# Addendum Number One (1)

## **New Baseball Stadium Athletic Complex Facility – Phase 2 Louisiana State University Eunice Eunice, LA**

**State of Louisiana  
Office of Facility Planning and Control  
Project No.: 19-605-22-02, F.19002637  
Site Code: 4-01-006**

**Issue Date:** April 10, 2026

C1.01

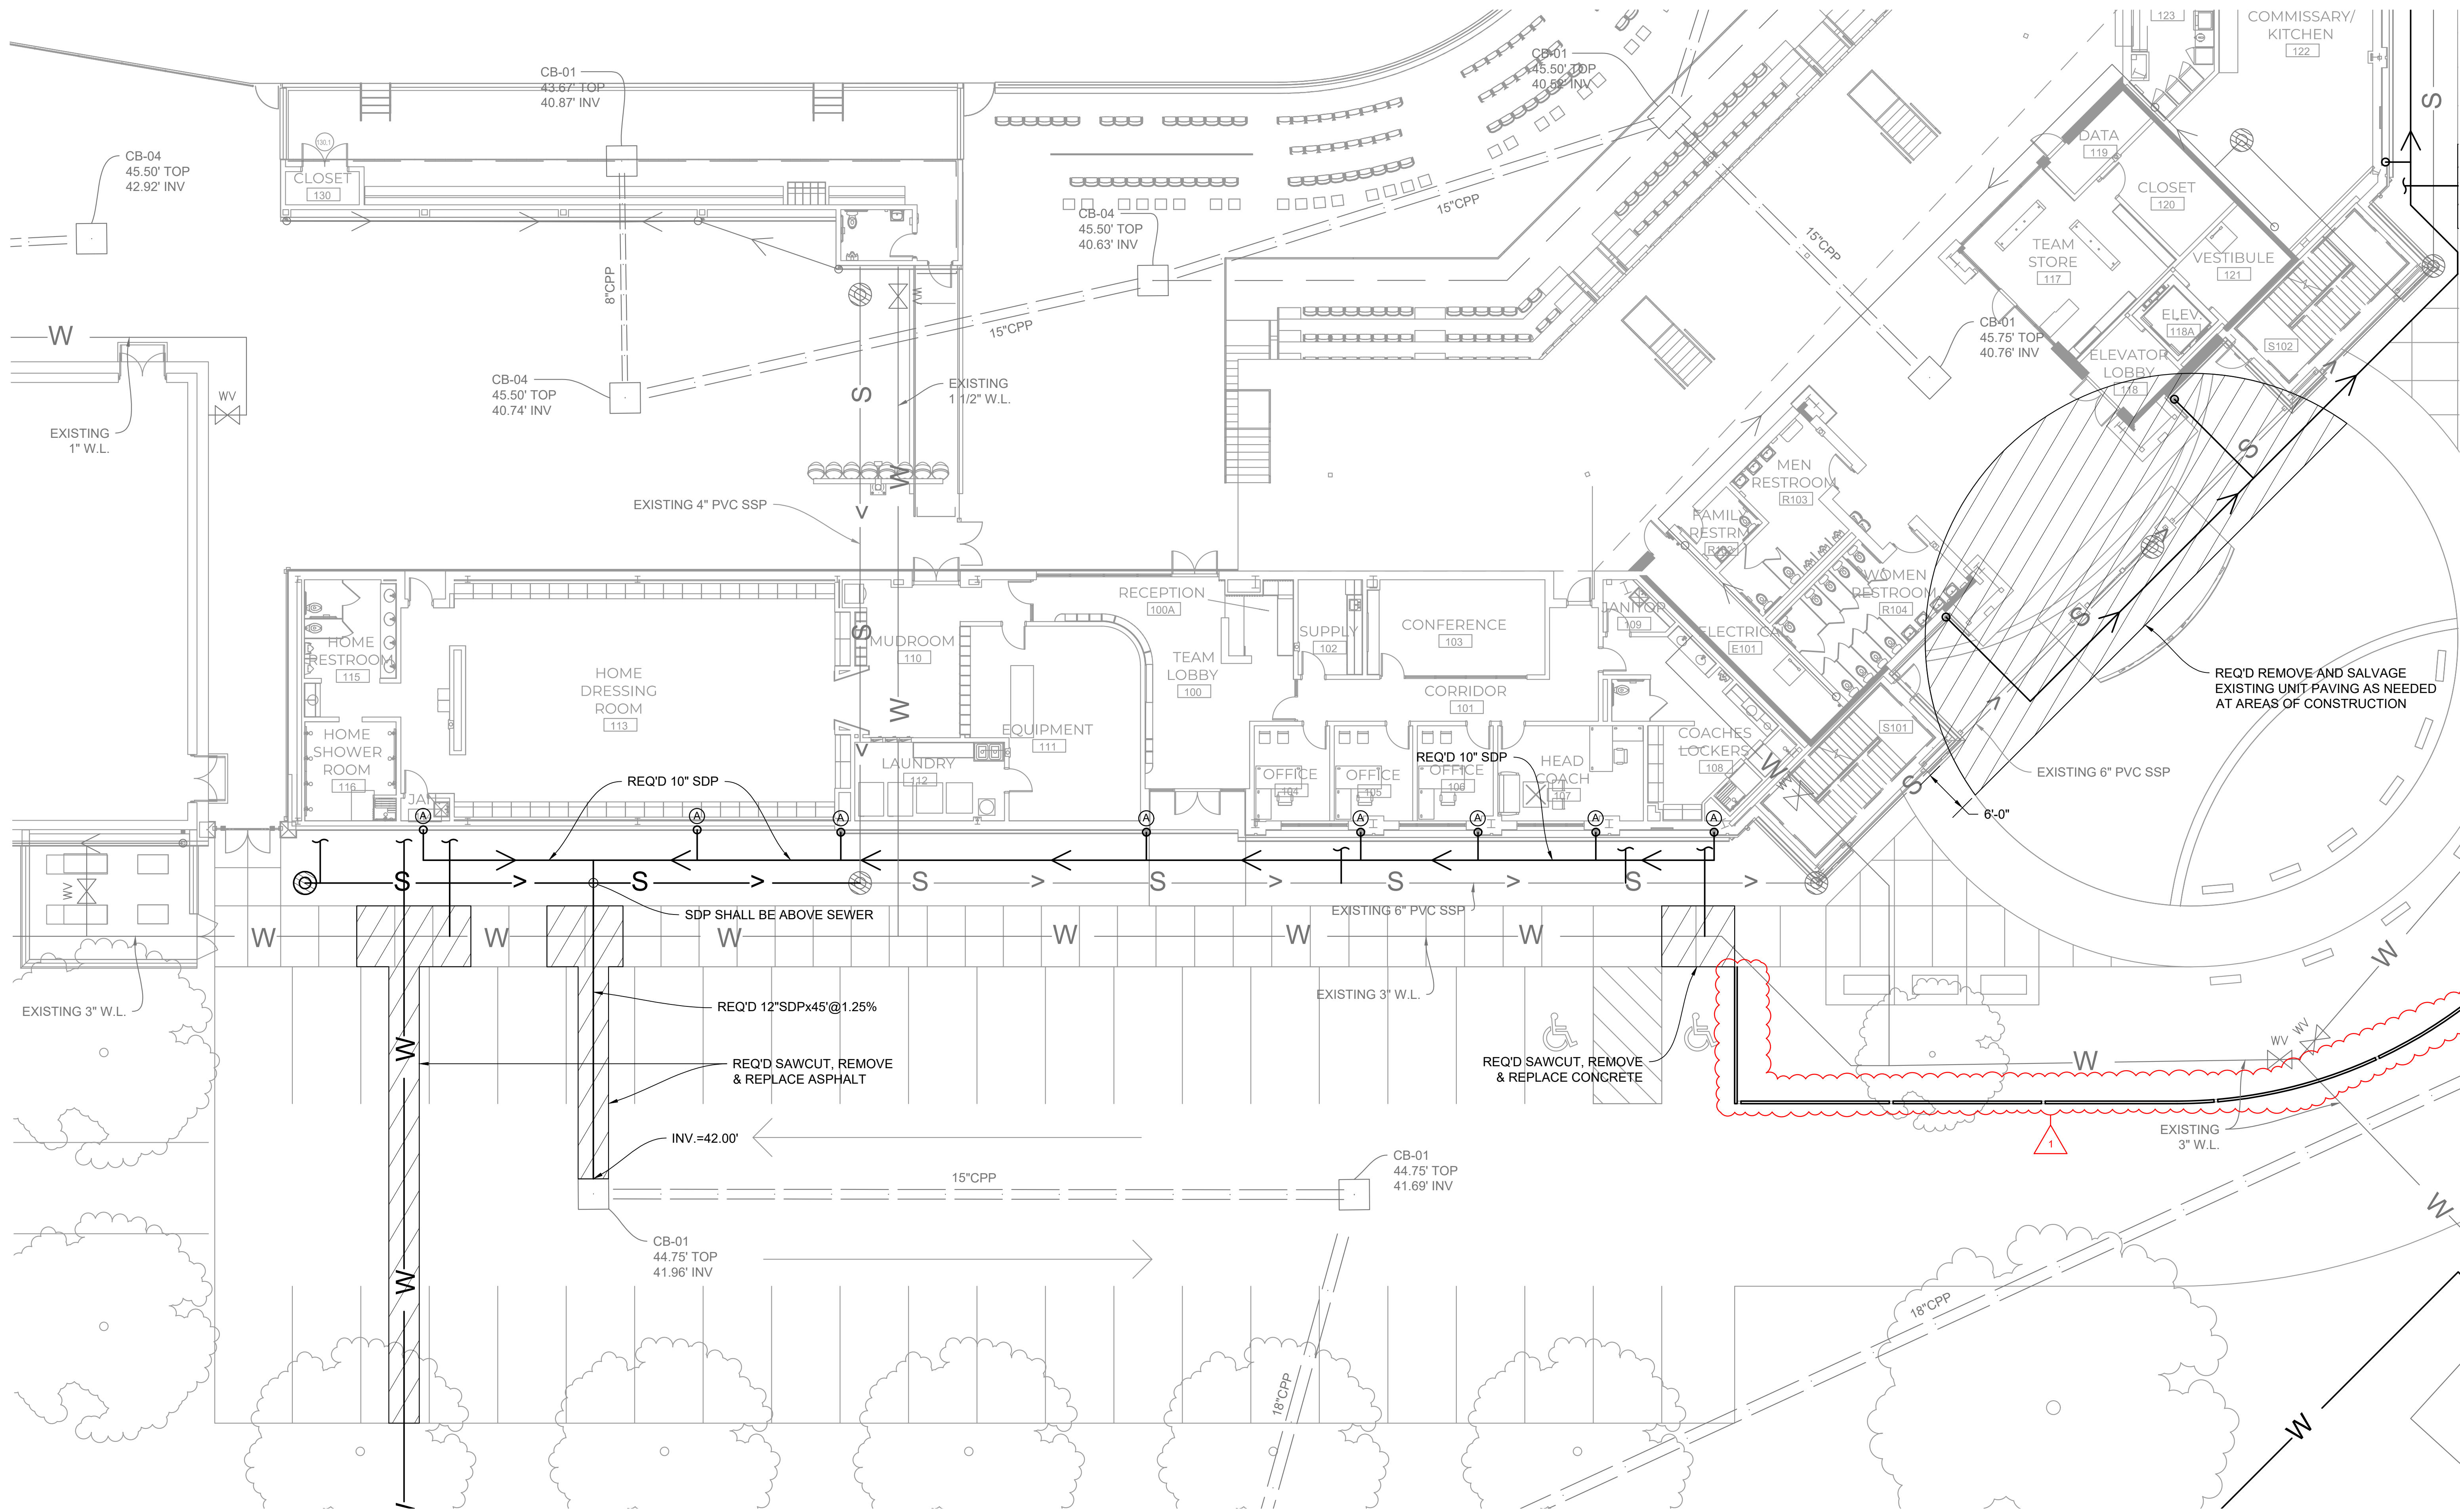
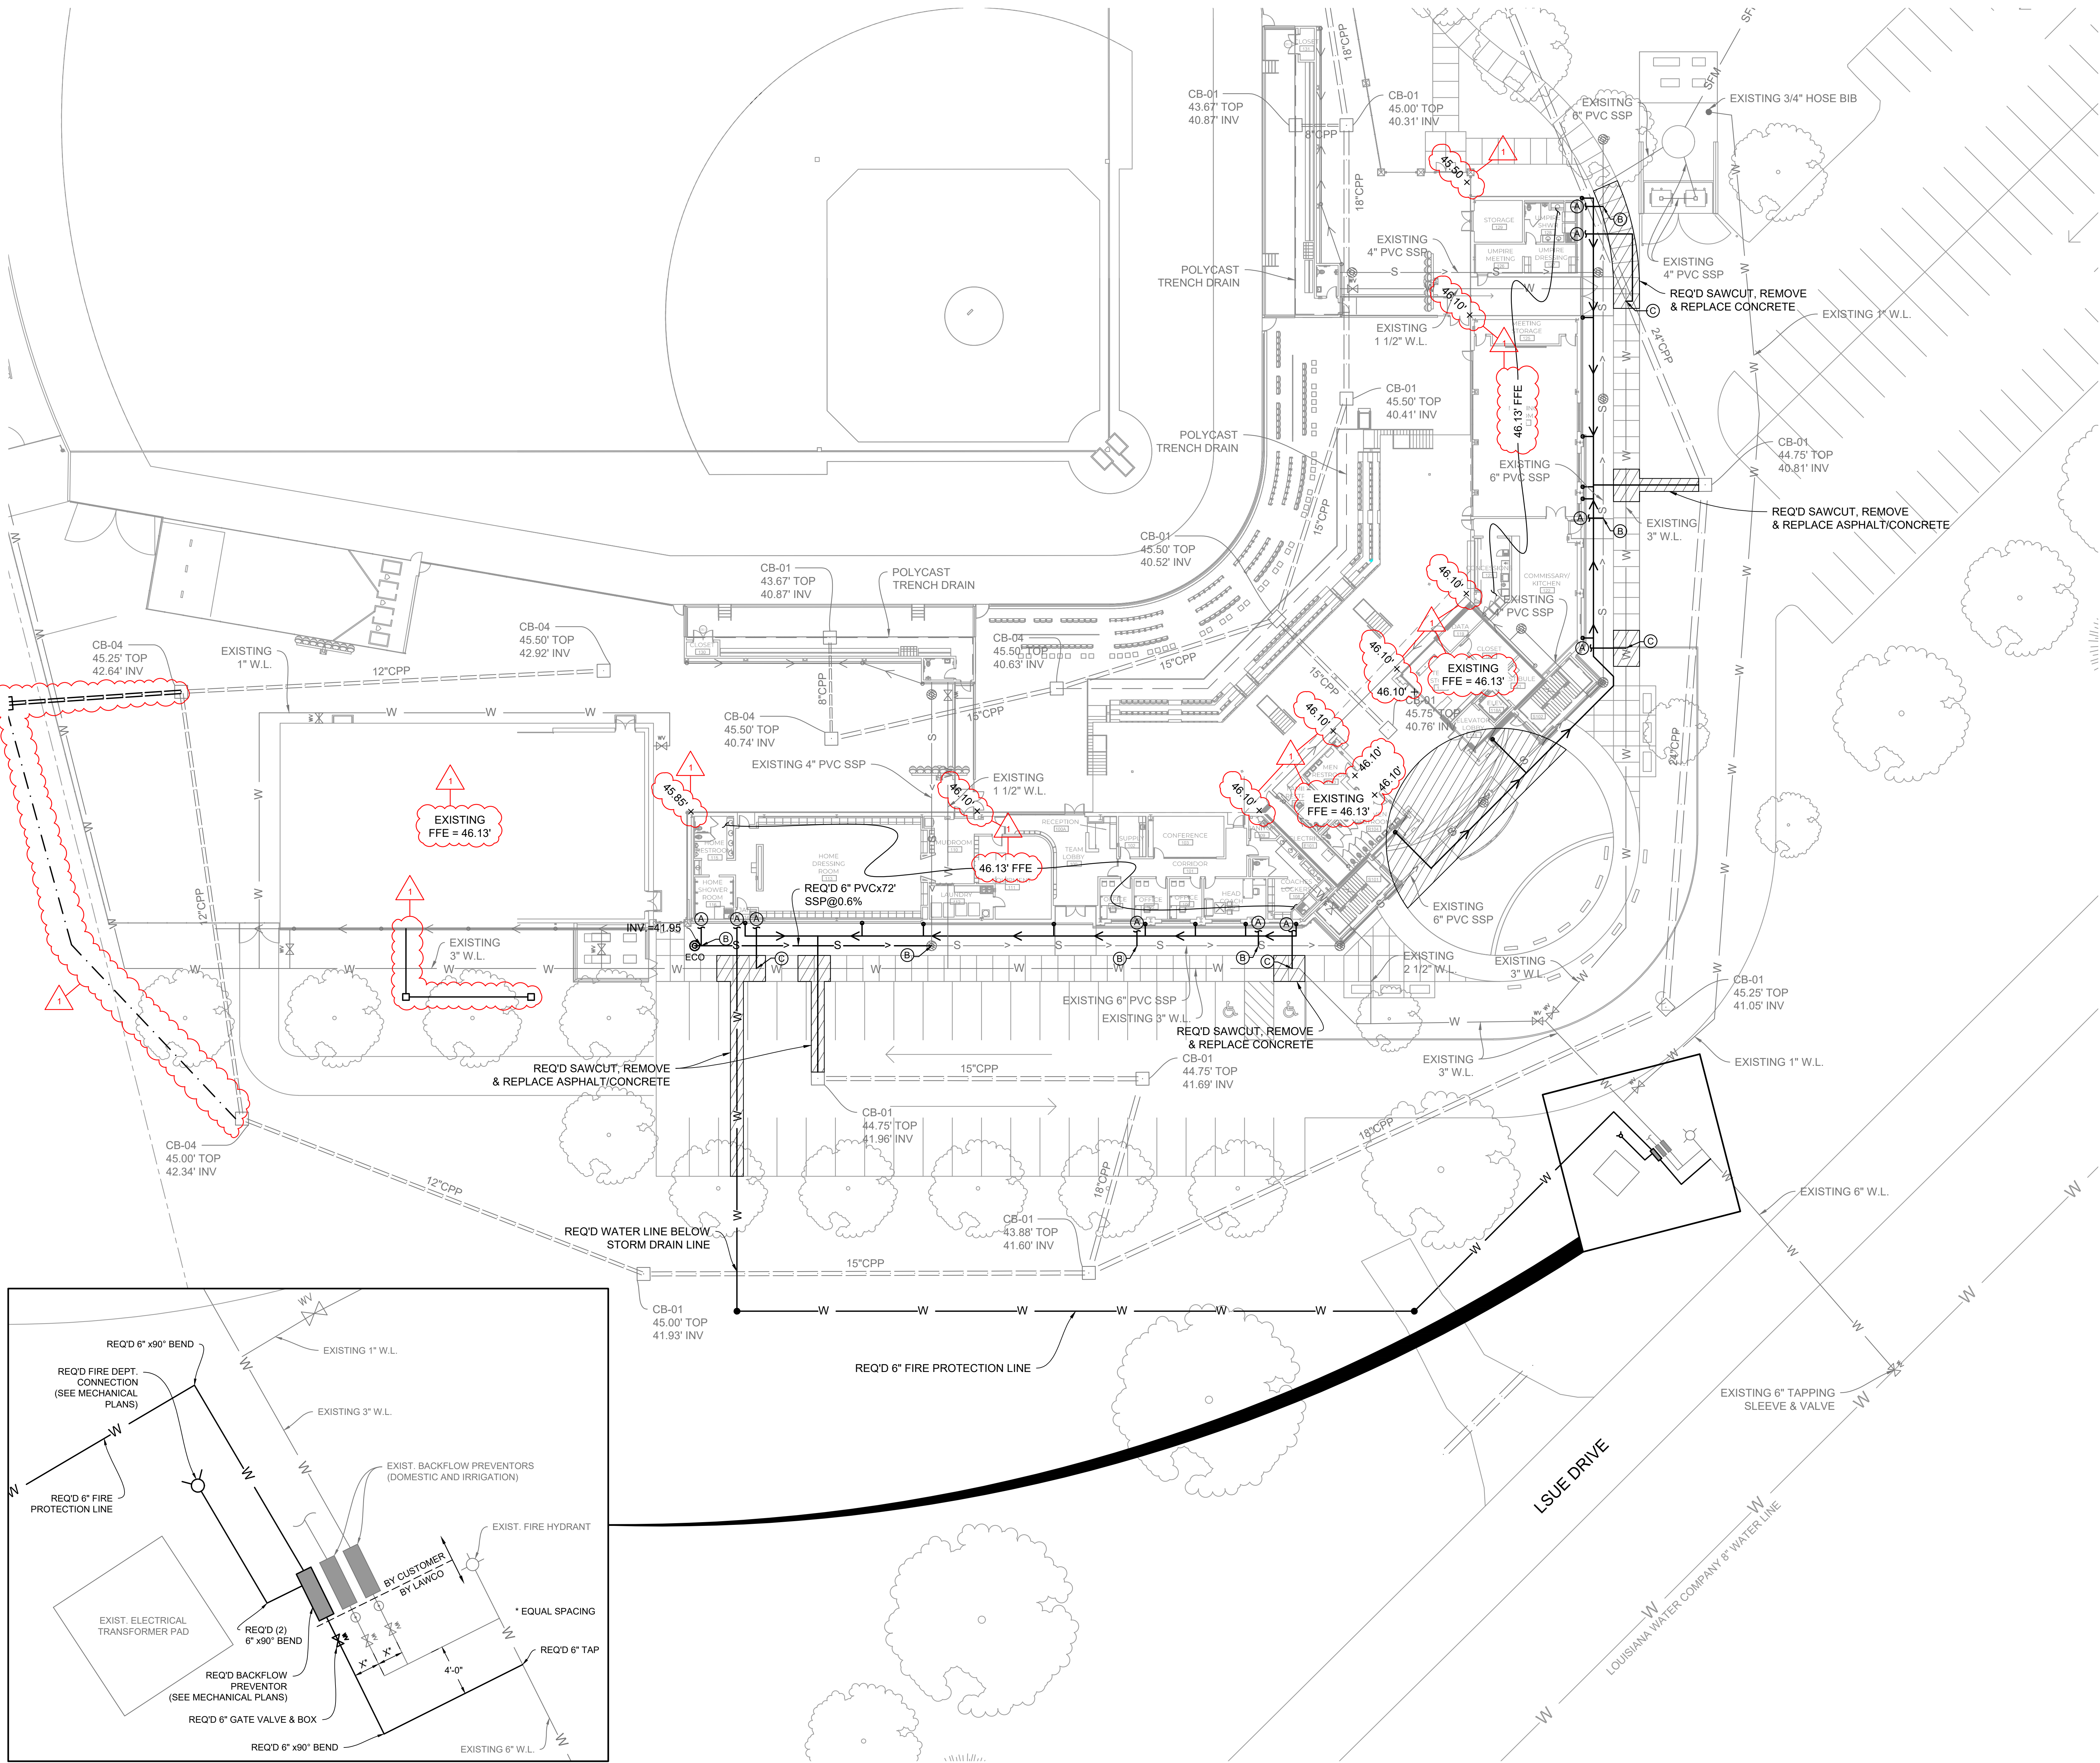
- 25. C1.01 – added existing adjacent pavement elevations and building FFE of 46.13'.
  - a. Added site drainage plan west and plan south of the existing Practice Building
- 26. C2.01 – added 4" rolled curb to edge of circle drive
- 27. C2.02 – added 4" rolled curb to edge of circle drive as well as notes
- 28. C2.03 – sheet added detailing the site drainage noted above
- 29. C2.04 – sheet added showing drainage work to the existing drainage ditch off the main highway.
  - a. Refer to General Clarification note 3, 3a, 3b above.
- 30. C3.01 – added rolled curb detail to sheet
